Subject: **Sunthurst Energy, LLC (Sunthurst)**
Oregon Community Solar Projects 024, 062, and 063 interconnections

My June 2 letter included an attached list of technical questions regarding PacifiCorp findings in the Oregon Community Solar (OCS) 062 and OCS 063 System Impact Study (SIS) Reports, and asked that PacifiCorp toll its deadline for executing the Facilities Study Agreement while the technical questions were resolved. PacifiCorp provided responses to nearly all questions for OCS 063 on June 4 (which I address below), and you also sent a response letter dated June 9. PacifiCorp, through Kris Bremer, responded to questions regarding OCS 024 on June 18. **But as of today, Sunthurst has not received responses to the OCS 062 questions on page 5 of my June 2 letter** (attached hereto as **Attachment A**). I respond to PacifiCorp's June 4 and June 9 letters below.

Light Load calculator showing 5W202 daytime light loading of 2.66 MW on 6-14-20 at 0800 for a 15 minute average

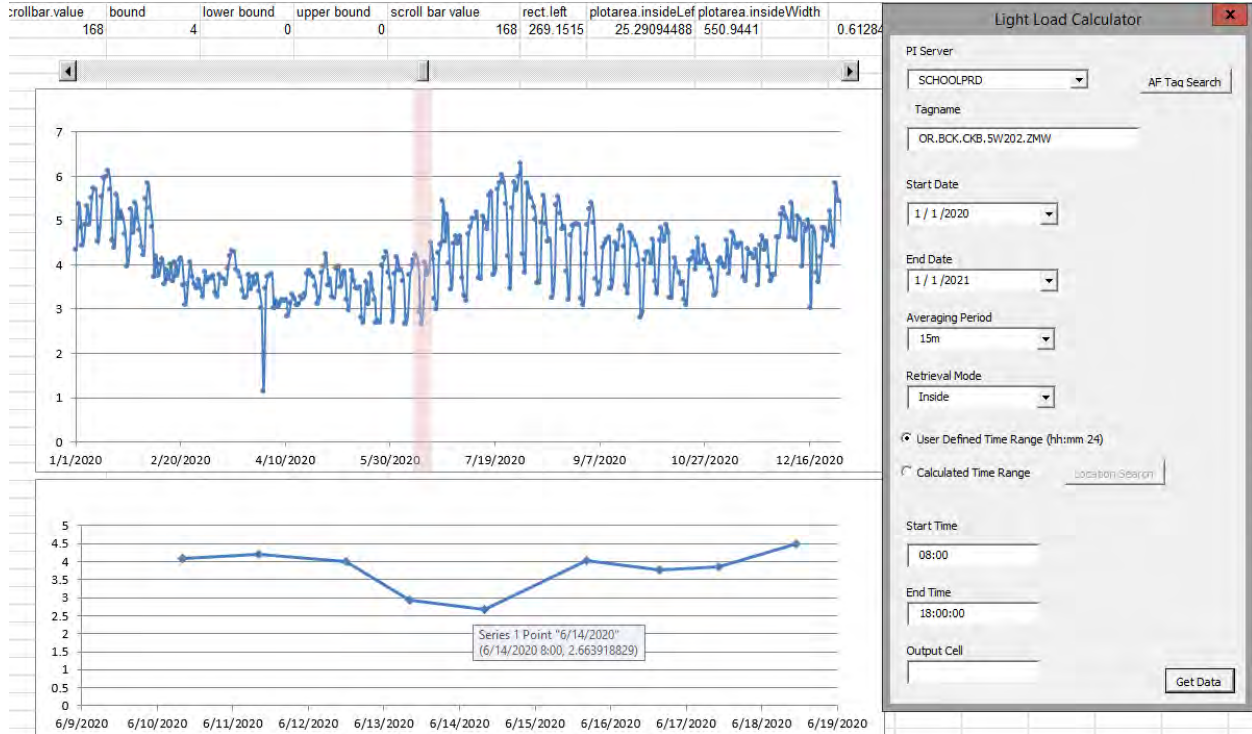
Pg 8- You state an MDL for 5W202 is 1.62MW. We request certified backup of the measurement records with time. PAC’s UM2000 data clearly shows the MDL is 3.0MW and this source is the value UM1930 was predicated upon.

Below are the MDL calculations for Buckaroo feeder 5W202.

- MW SCADA loadings on the 5W202 feeder under the existing circuit topology readings on 6-14-2020 at 8:13 AM show 2.61 MW with a 15 minute average calculated at 2.66 MW.***
- Using PacifiCorp’s CYME distribution system model it is estimated the MDL on the remaining 5W202 load is 1.65 MW after the load transfer to the new McKay feeder 5W856.***
